U S NAVY RESPONSE TO SOUTH CAROLINA DEPARTMENT OF HEALTH AND
ENVIRONMENTAL CONTROL COMMENTS ZONE H RCRA FACILITY INVESTIGATION
WORK PLAN ADDENDUM SOLID WASTE MANAGEMENT UNIT 196 (SWMU 196) CNC
CHARLESTON SC
2/15/2000
CH2M HILL

**RESPONSE TO SOUTH CAROLINA DEPARTMENT OF
HEALTH AND ENVIRONMENTAL CONTROL COMMENTS
ZONE H RFI WORK PLAN ADDENDUM
SWMU 196 dated NOVEMBER 18, 1999**

**South Carolina Department of Health and Environmental Control
Response to Comments
Zone H RFI Work Plan Addendum for SWMU 196
dated November 18, 1999**

**WELL CONSTRUCTION
BORING LOG**

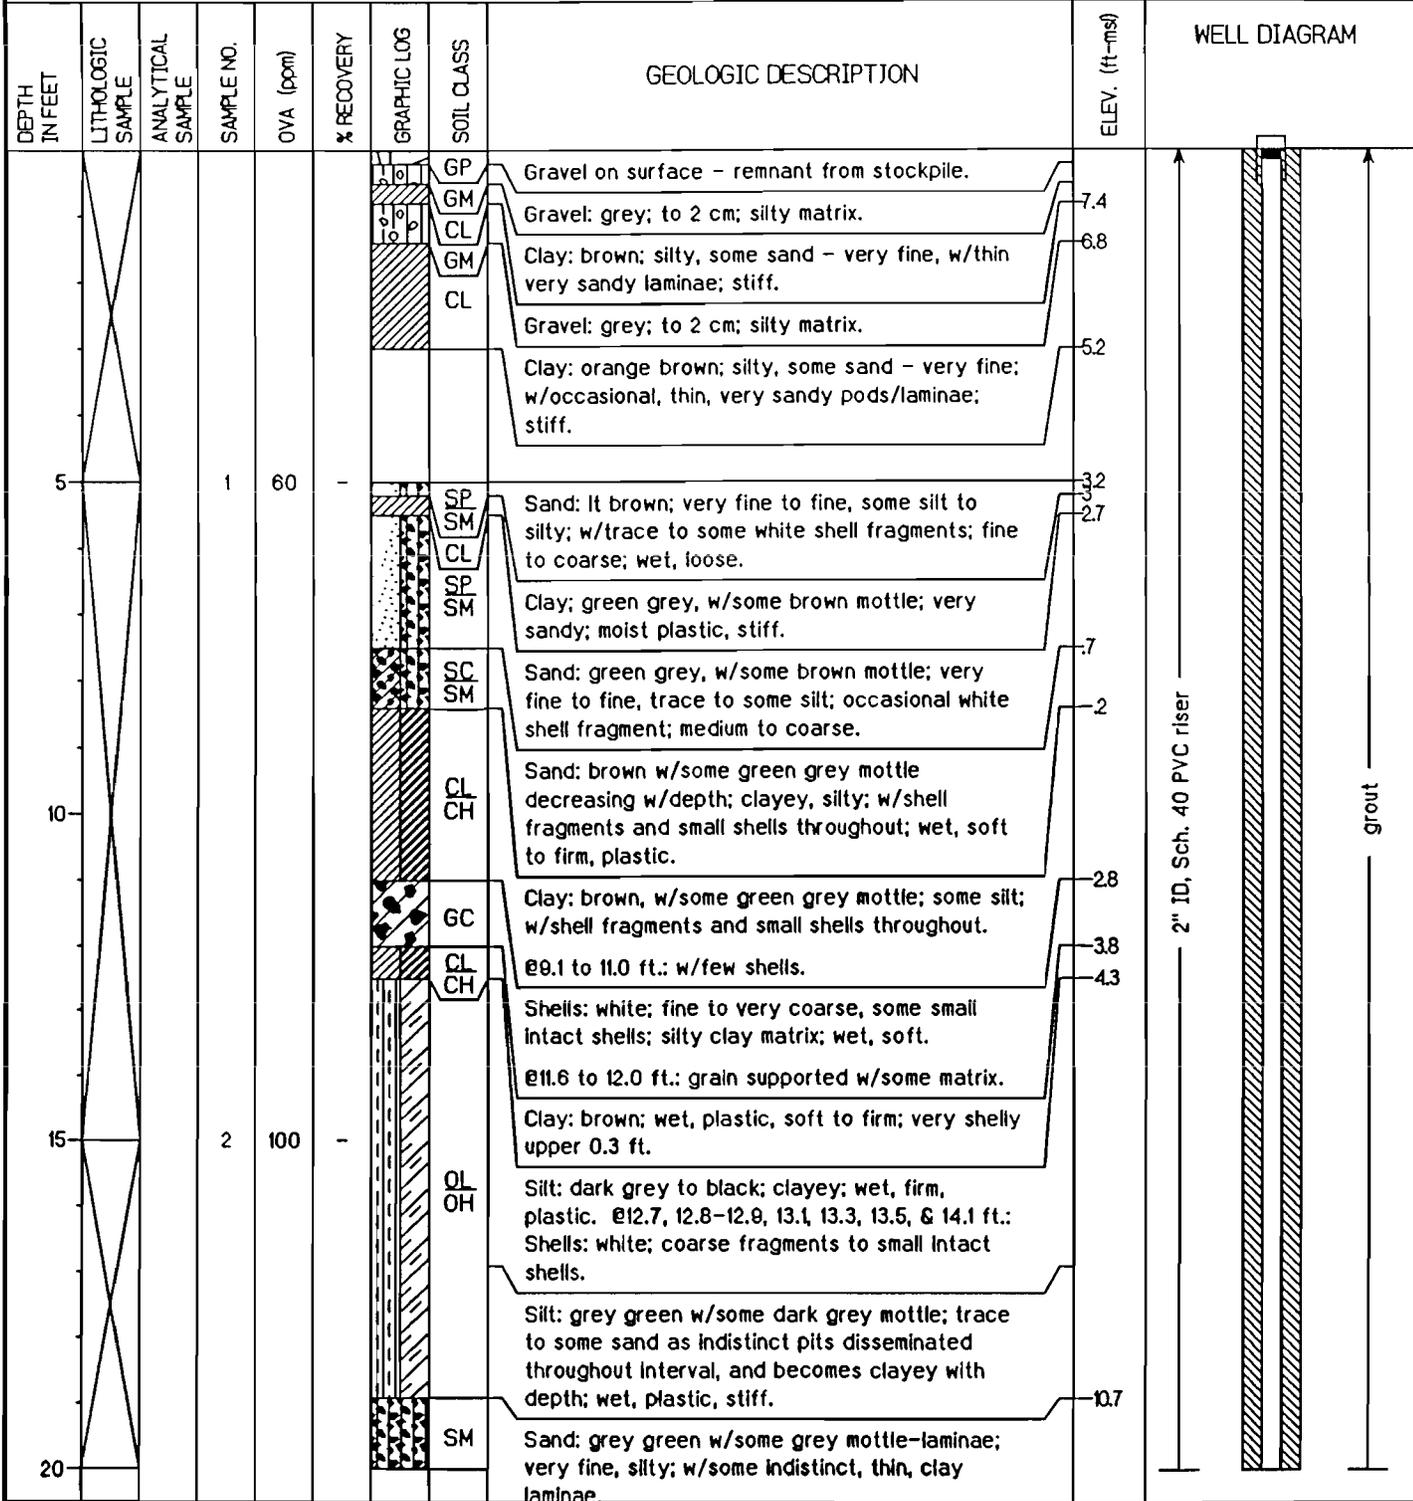
The deep well 00923D is stated to be 36.8 feet in depth. The text is not clear as to which geological formation this well terminates. Please provide the geological information and construction details for this well.

is clean. Even though the available data suggests there is no contamination in the deep zone, the project team agreed that the affects of the top of the Ashley formation sloping away from the site does introduce some amount of uncertainty into the situation. To manage this uncertainty, the team agreed that it would be prudent to install a deep well to the northeast of Building 1838 near the shallow well 196-002. A revised Figure 7 is attached to these responses to document the proposed location in lieu of revising the work plan. Also, as requested in the comment, a sketch of the boring log and construction details for well 00923D are attached.

FIGURE 7
SWMU 196
MONITORING WELL, SOIL BORING,
SEDIMENT SAMPLE, AND SURFACE WATER
SAMPLE LOCATIONS

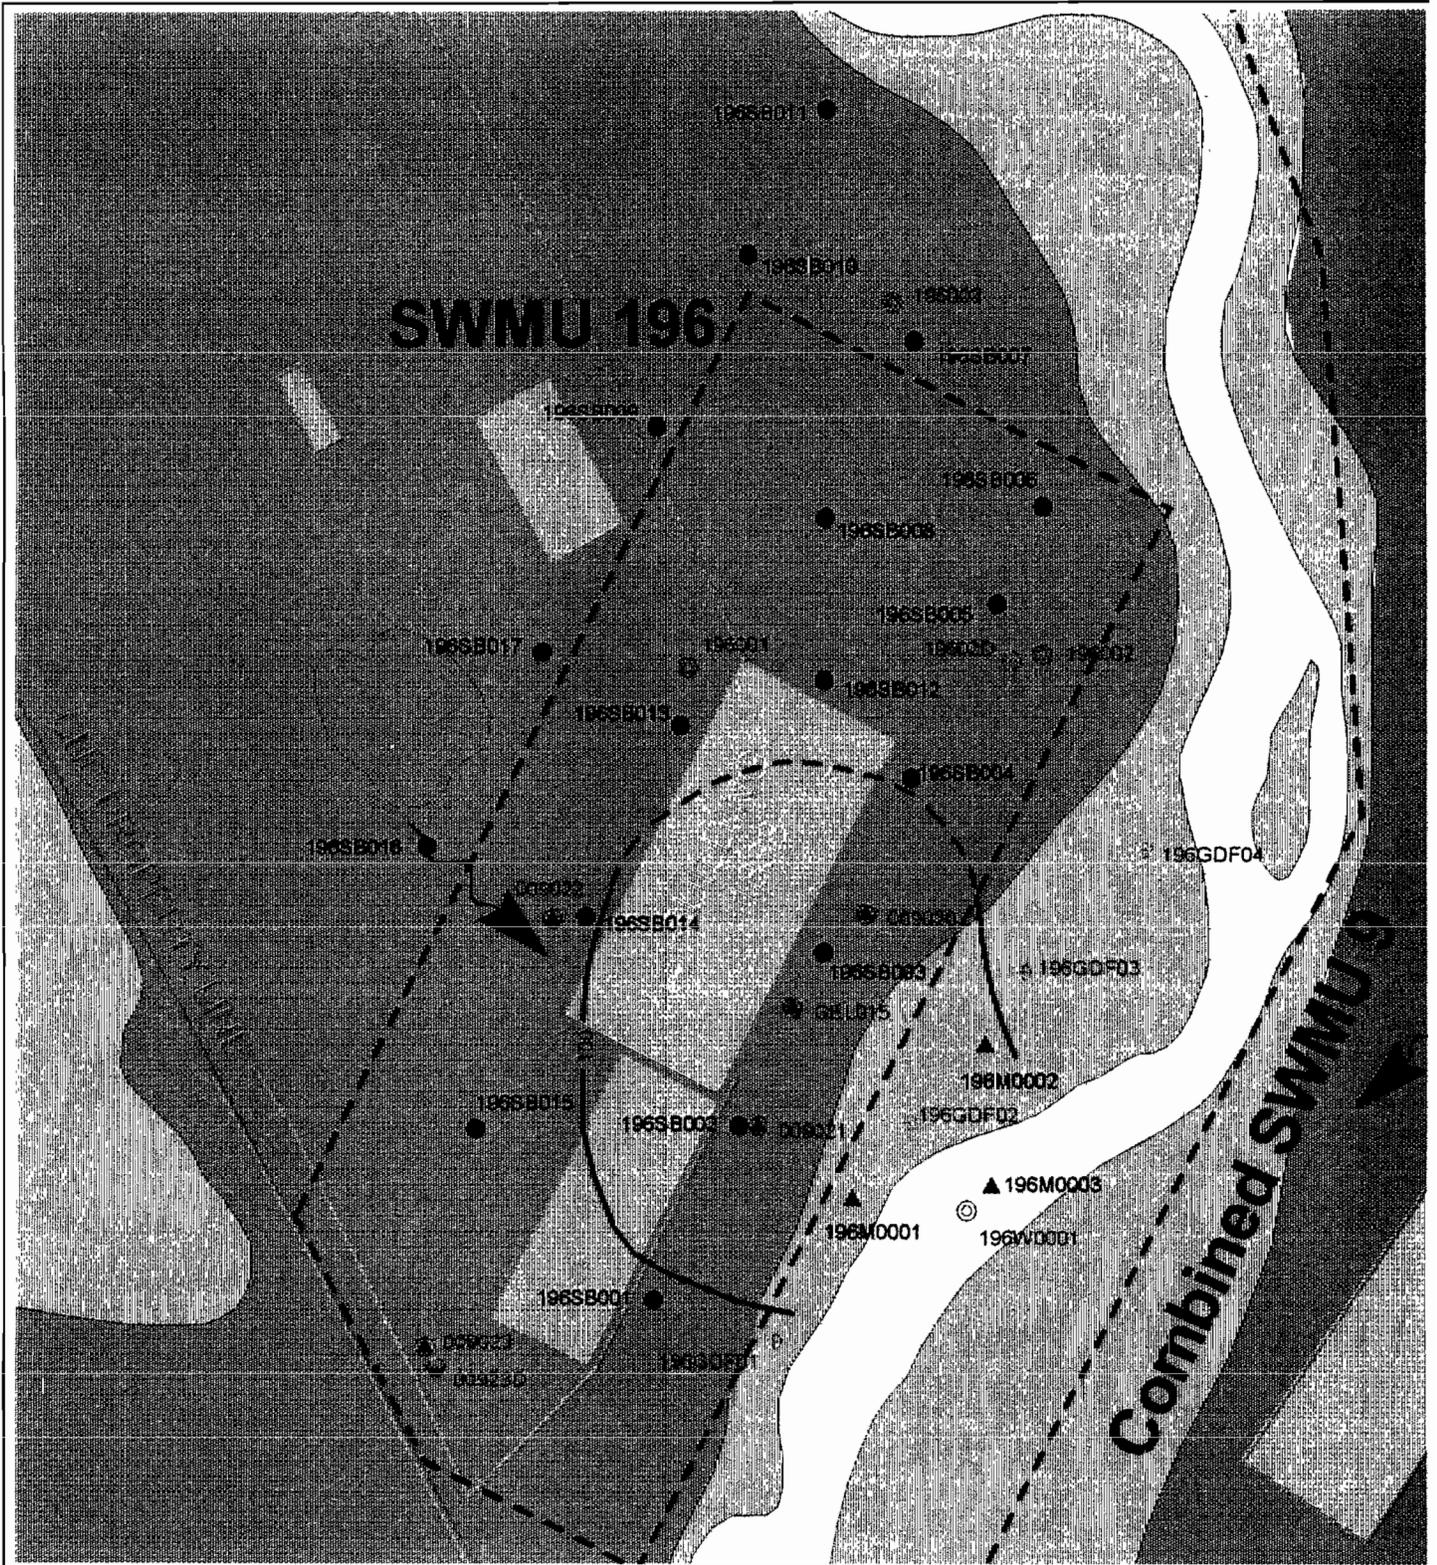
Page 26 Table 7

The table references sample locations with existing well numbers. The well numbers 196GDF01, 196GDF02, and 196GDF03 were not located on the proposed sample location map, Figure 7. Please provide a revised location map or an explanation of the well numbers for verification of the sample locations.

Figure 7 has been revised so that the referenced wells are present.
